**Addendum No. 1 December 13, 2024**

**Craft Center Upgrades**

**Tennessee Technological University**

**Revisions and Clarifications to the Drawings or to the Project Manual:**

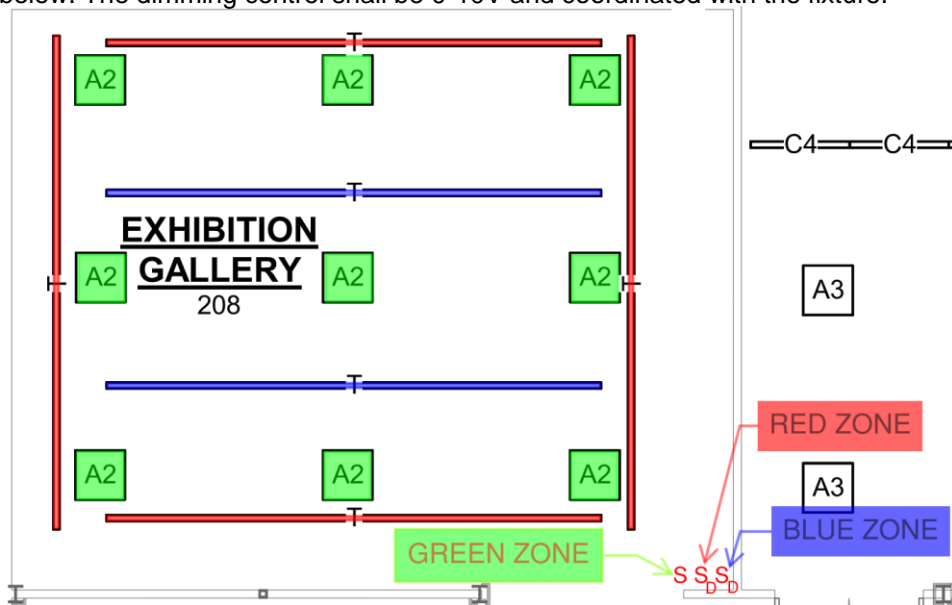
Answer: The P fixtures are a one-for-one replacement. The new fixtures shall be oriented the same as the existing fixtures.
12. Plan sheet E2.1 shows a lighting fixture "T" at the Main Level in Exhibition Gallery 208. There is a fixture "T4" shown on the Lighting Fixture Schedule on E0.1 but not a "T" fixture. Please let us know what to allow for the T fixture.

Answer: The Type T fixture shall be Solais Lighting LCM-x-nfl-950-2000-40. The contractor shall include 45 Type T fixtures evenly spaced along the path shown in the plans. The lighting in Exhibition Gallery 208 shall be divided into three zones as shown in the plan below. The dimming control shall be 0-10V and coordinated with the fixture.

**A1.3**  
 SHEET: ADMIN BUILDING ROOF  
 TITLE:  
 JOB NO.: 23028 DATE: 09-27-2024  
 DWN BY: CND

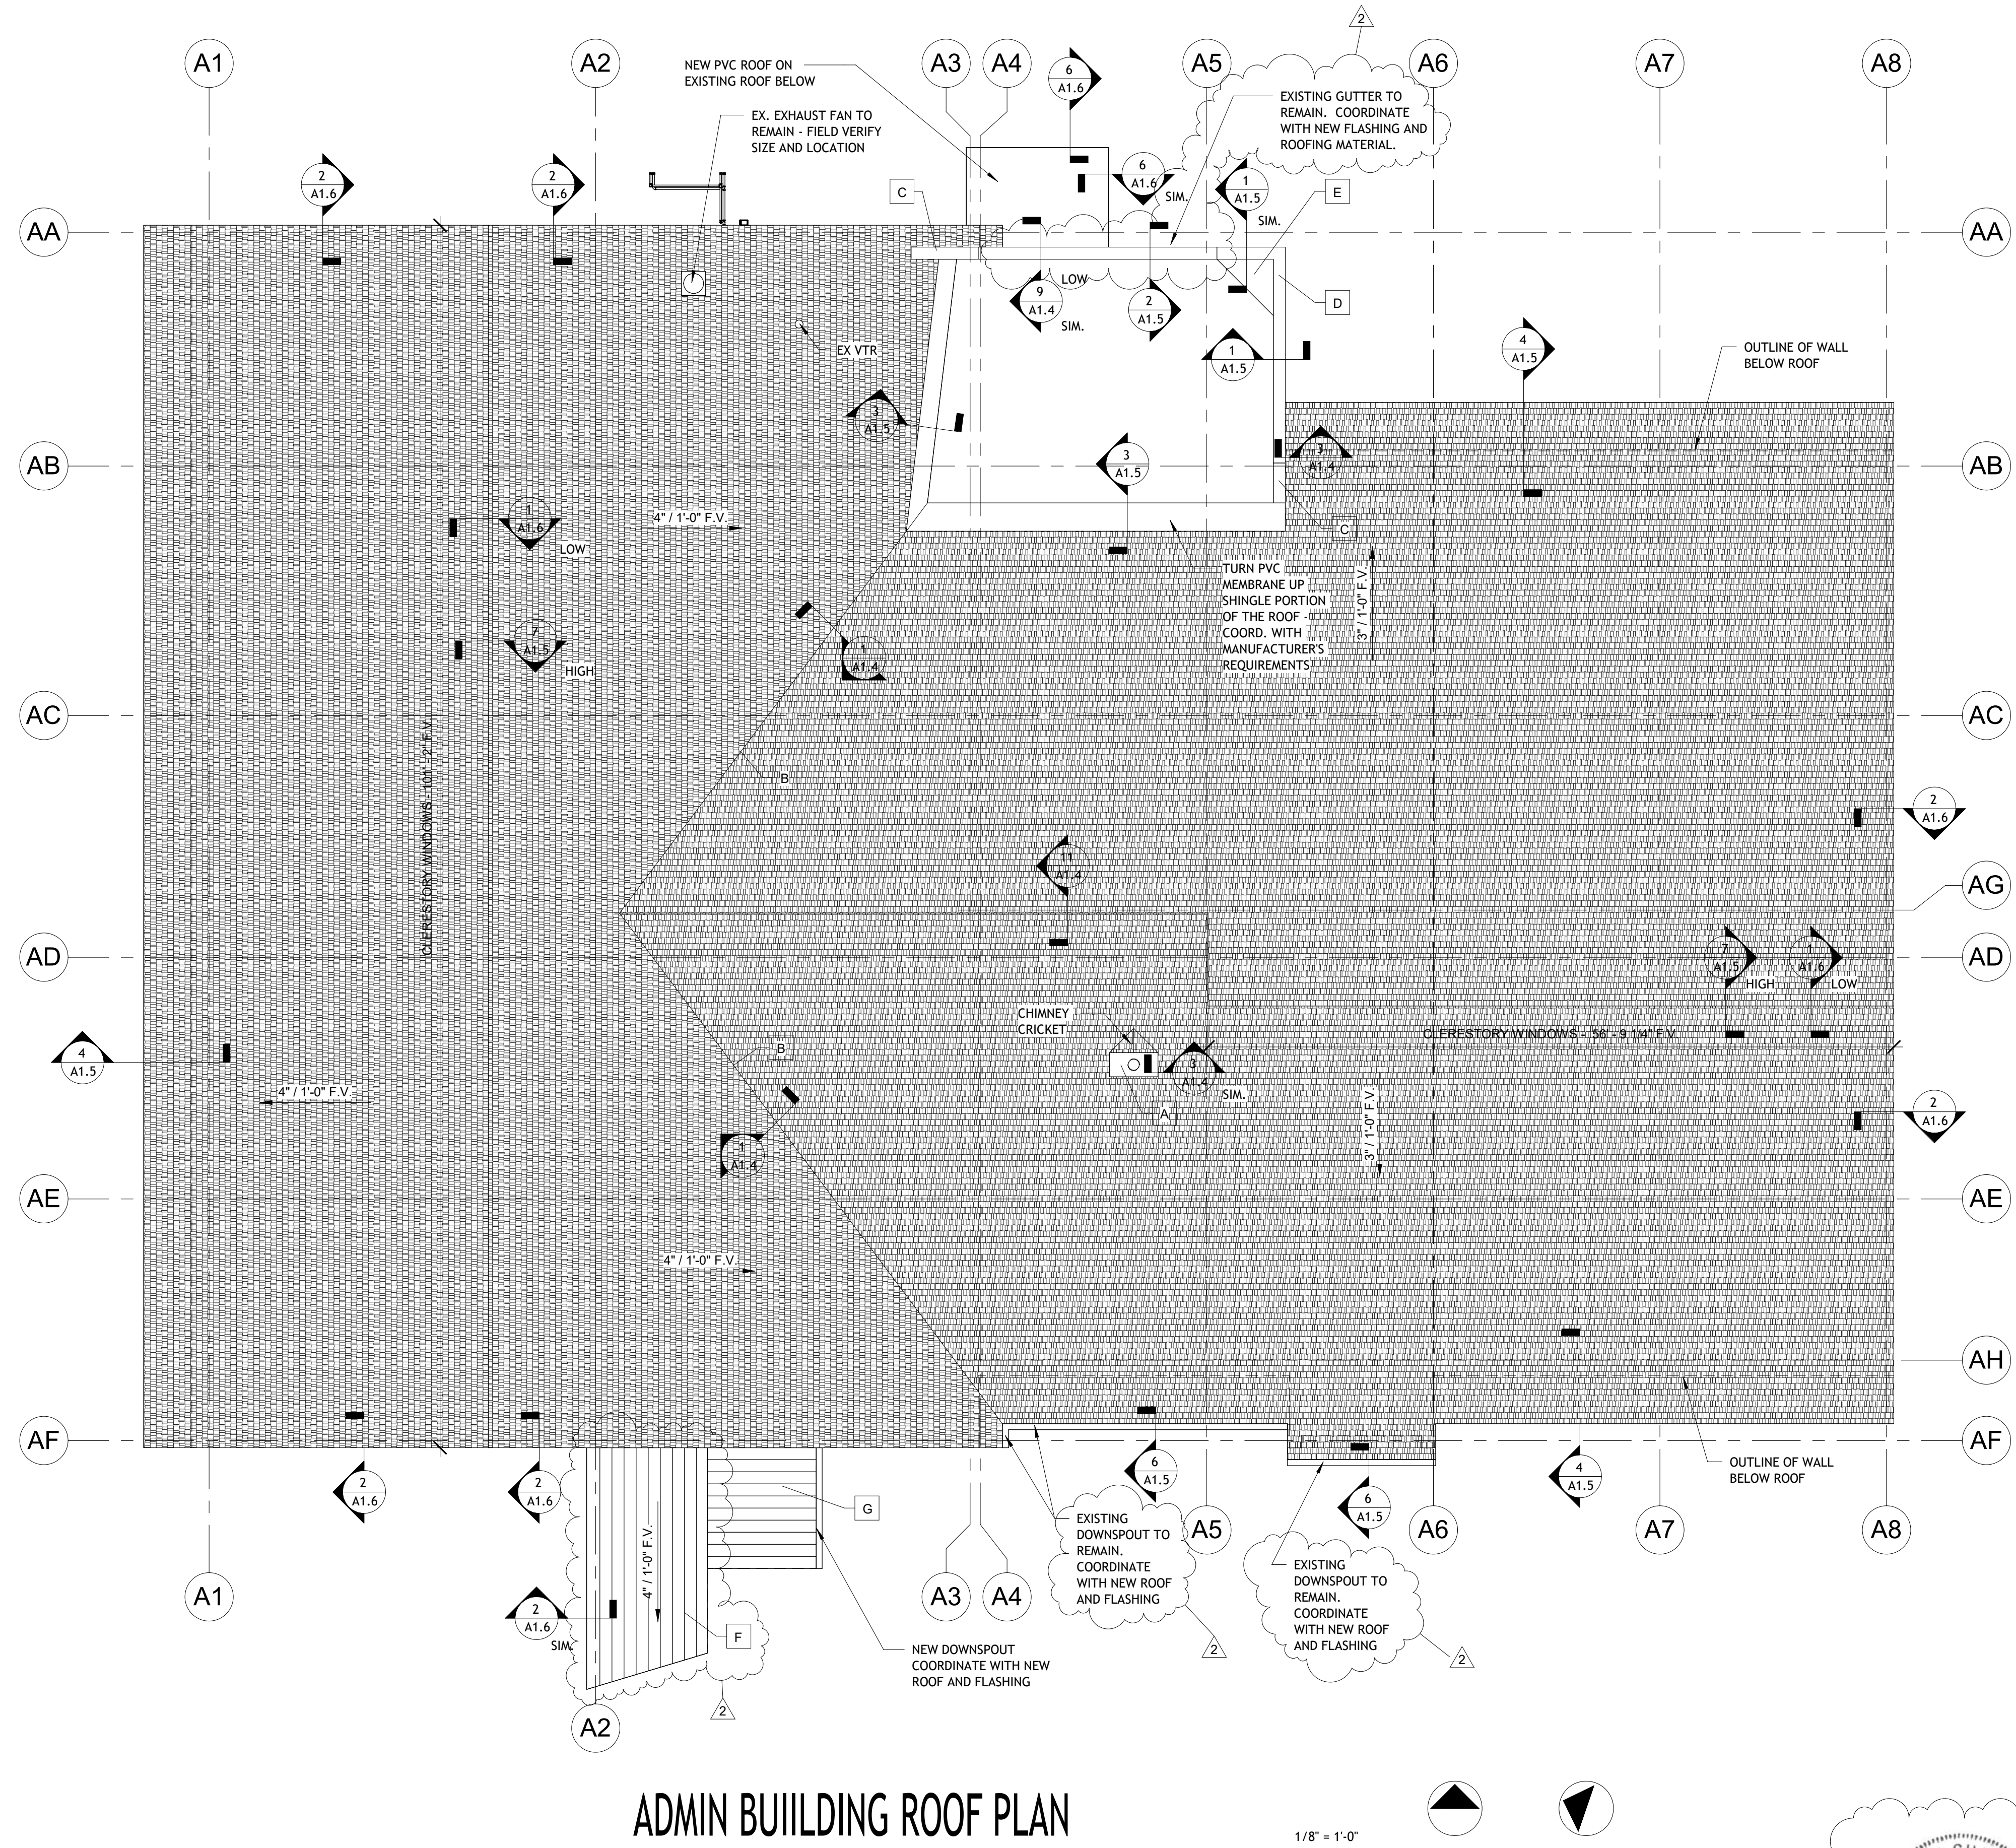
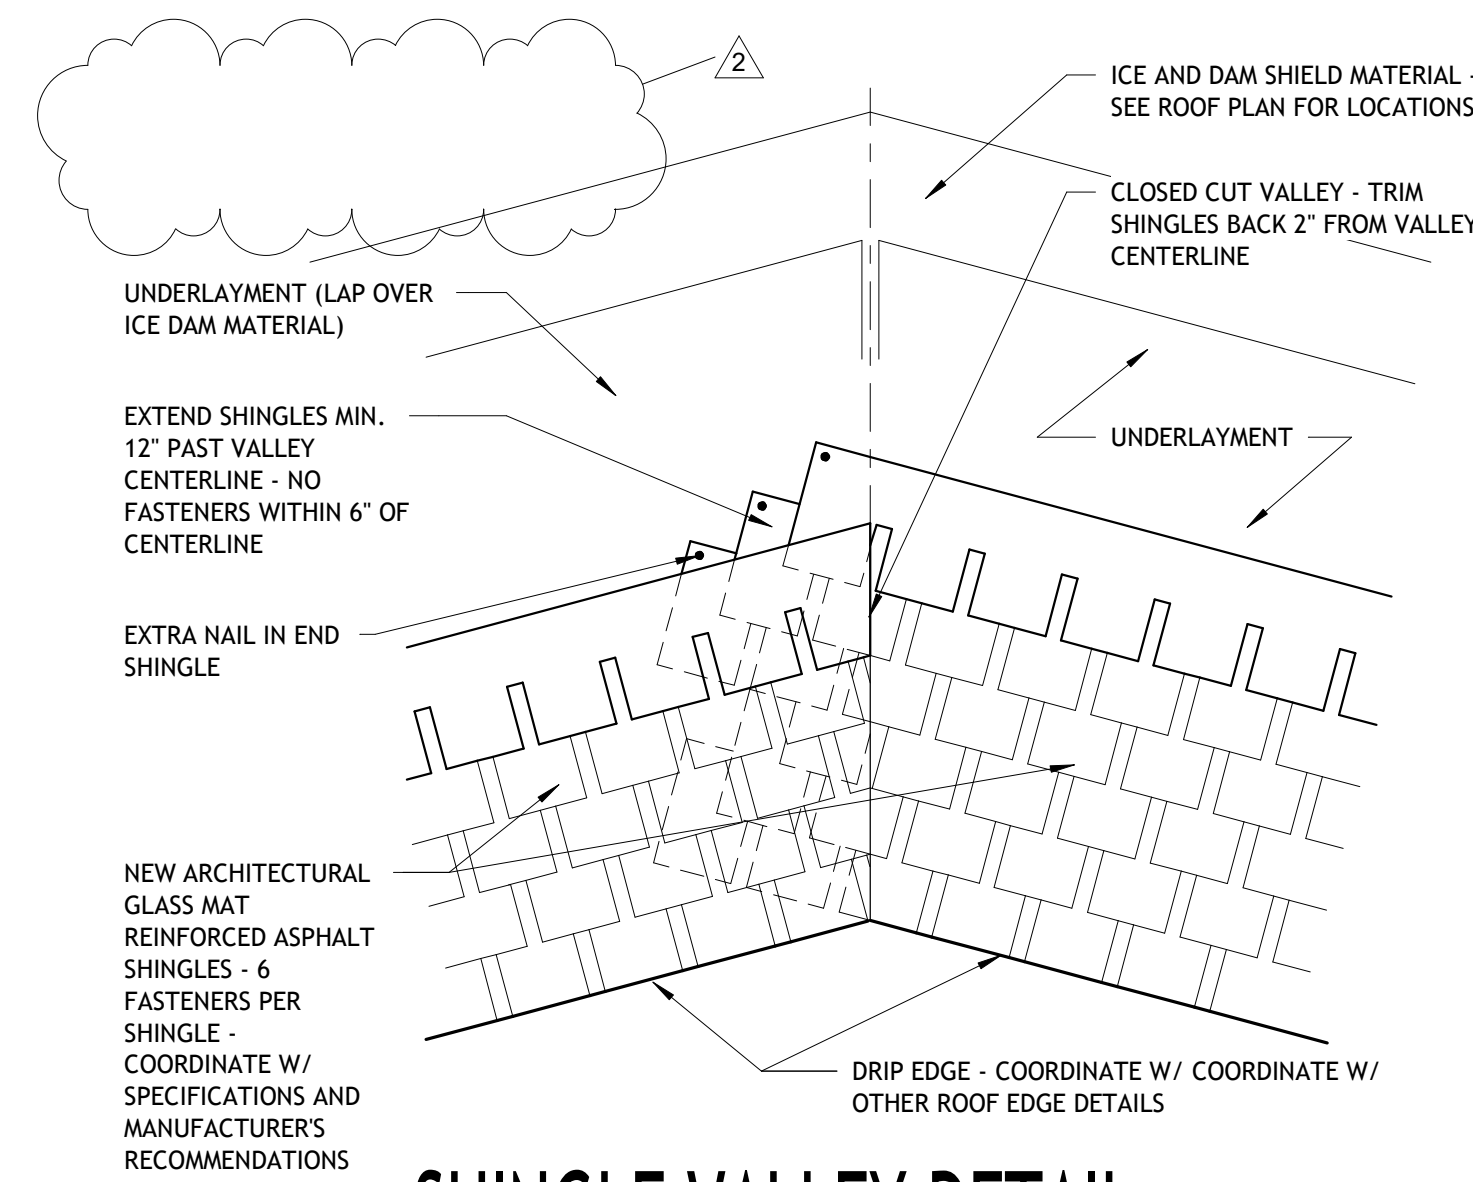
1. Refer to sheet A1.3 Admin Building Roof. Change references on roof plan regarding gutters and downspout per the attached A1.3 with revision tag 2 dated 12-13-24.
2. Refer to sheet A1.3 Admin Building Roof. There is a portion of the existing standing seam roof that is to remain. See revised attached A1.3 with revision tag 2 dated 12-13-24.
3. Refer to sheet A1.3 Admin Building Roof. Change Roof Symbol Legend – Admin. to read per the attached revised A1.3 with revision tag 2 dated 12-13-24.

4. Refer to sheet A1.3 Admin Building Roof. Change note 'F' to the Admin Roof Key Notes to read "Existing Metal Roof to Remain."
5. Refer to sheet A1.4 Admin Building Roof Details – Detail 1. Remove reference to  $\frac{3}{4}$ " exterior plywood on wood sleepers attached to existing tongue and groove wood deck.

ROOF DETAIL

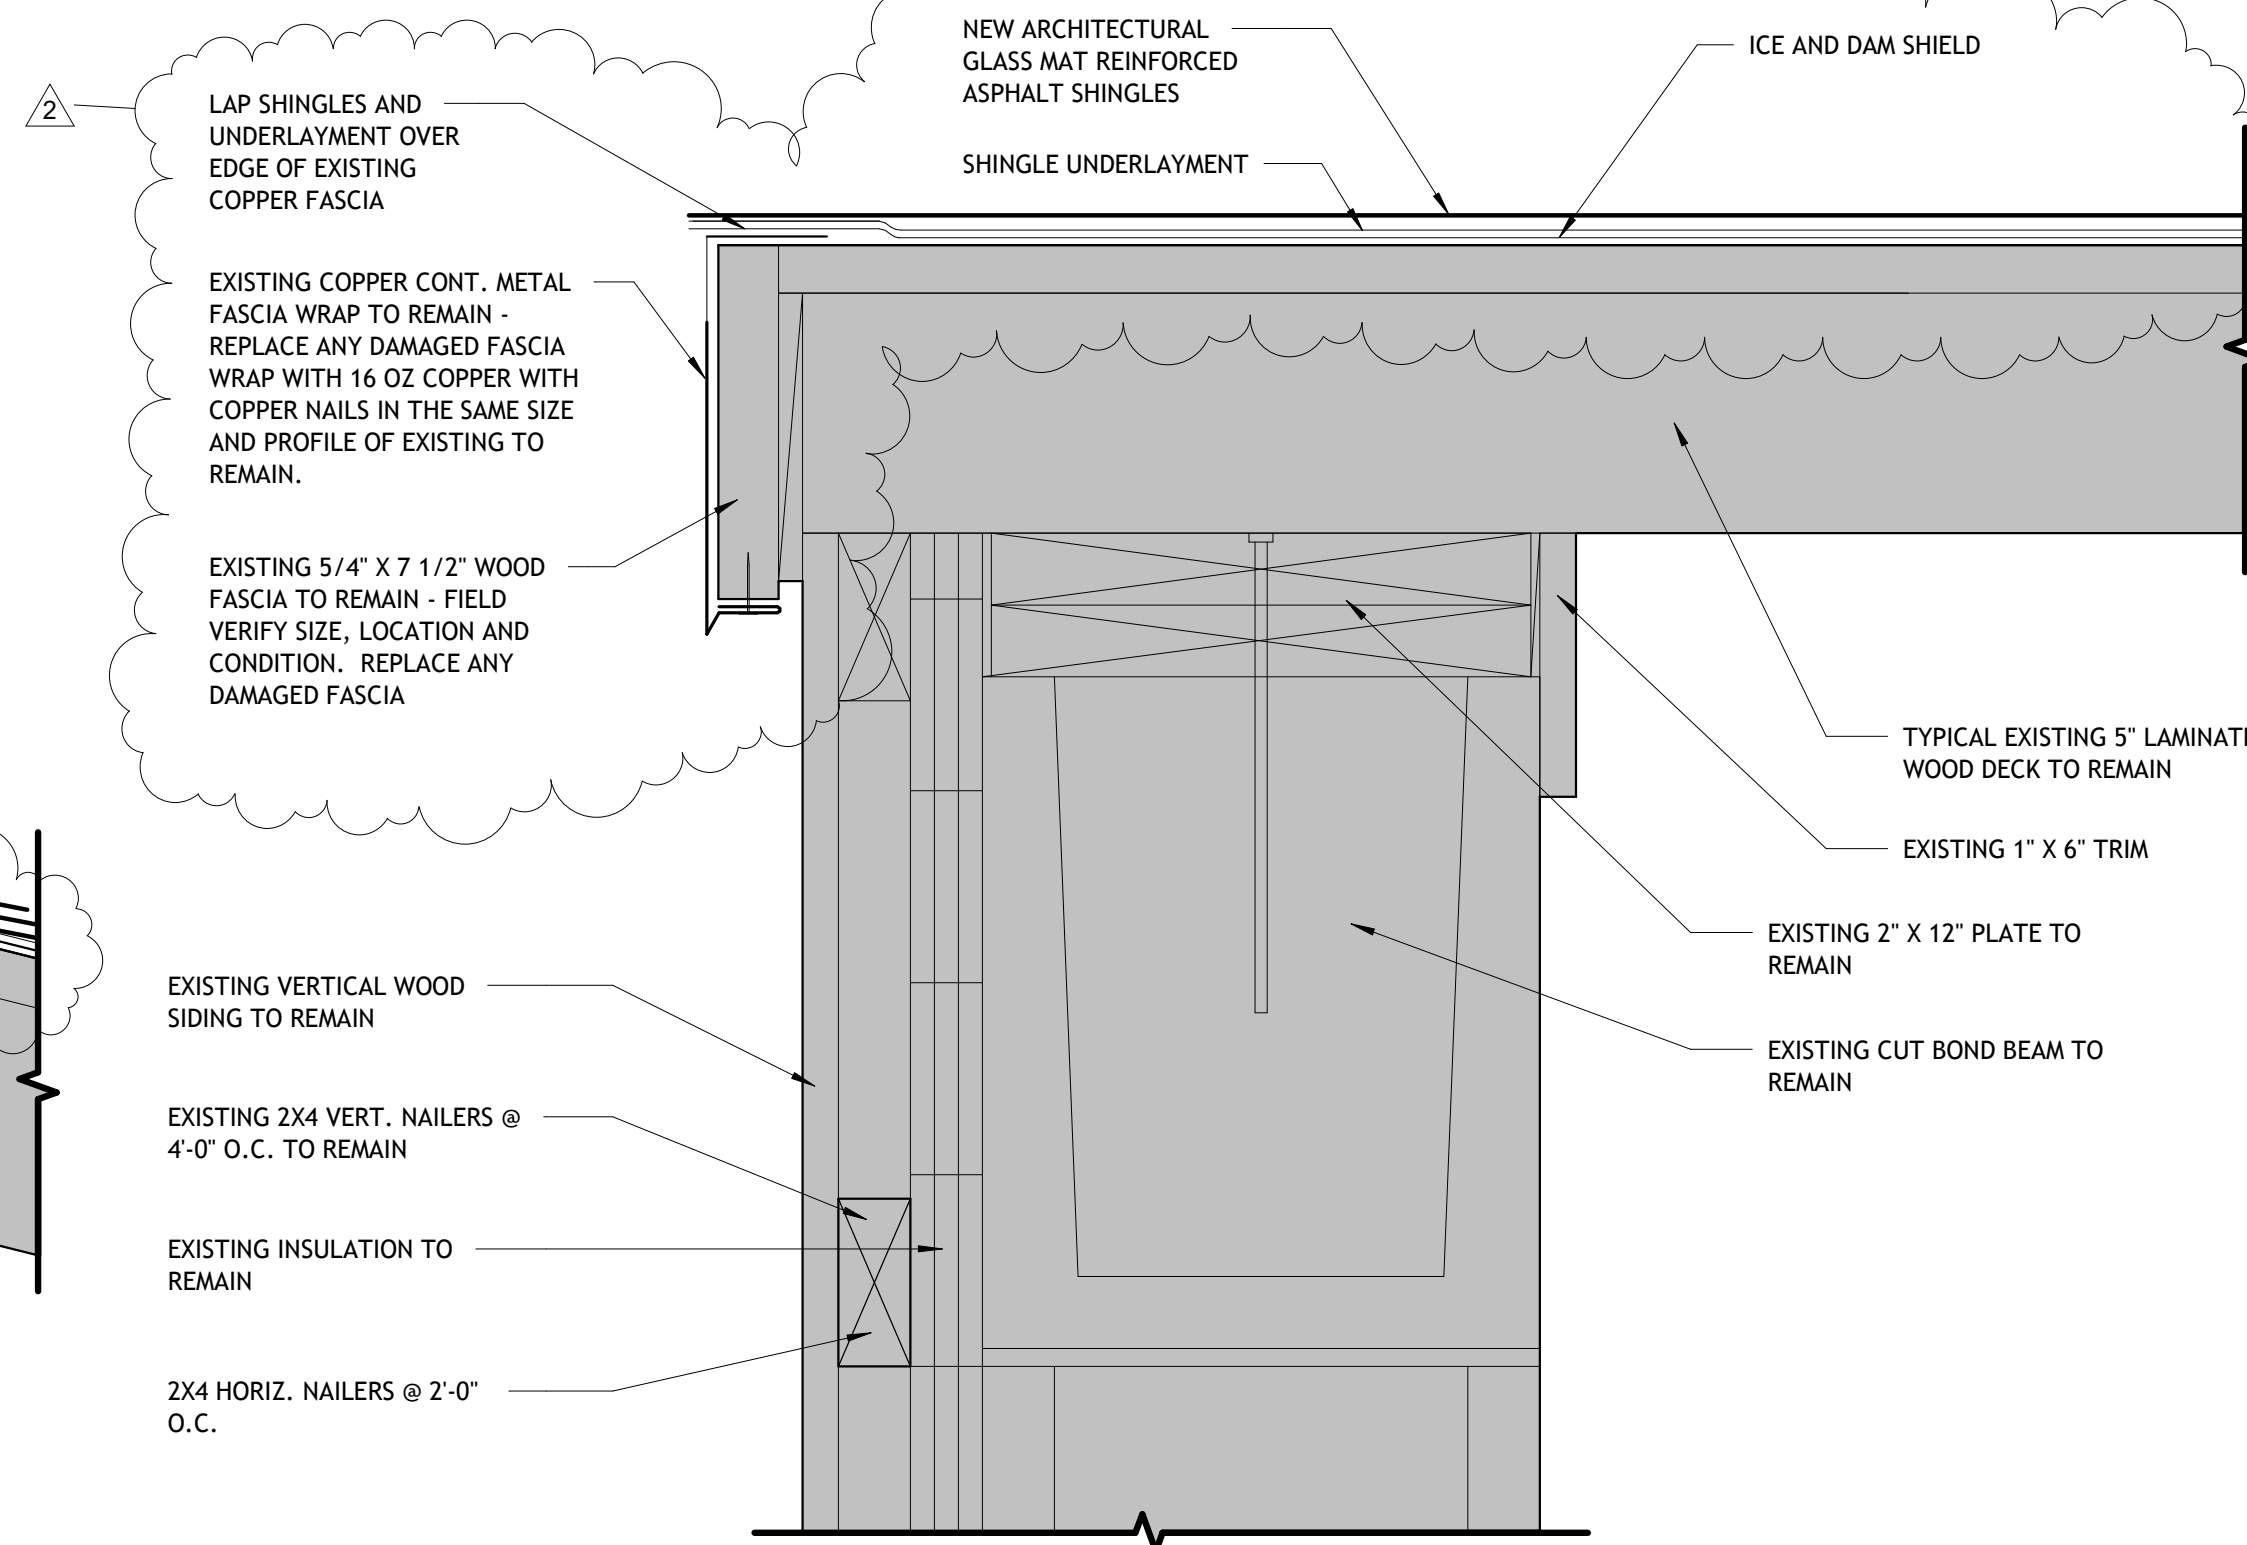
6. Refer to sheet A1.4 Admin Building Roof Details – Detail 4. Remove detail as it is not used.
7. Refer to sheet A1.5 Roof Details, details 1, 2, and 3. Remove references to built-up roof to remain. Change note to read "Remove existing EPDM roofing prior to placement of the hailguard board."
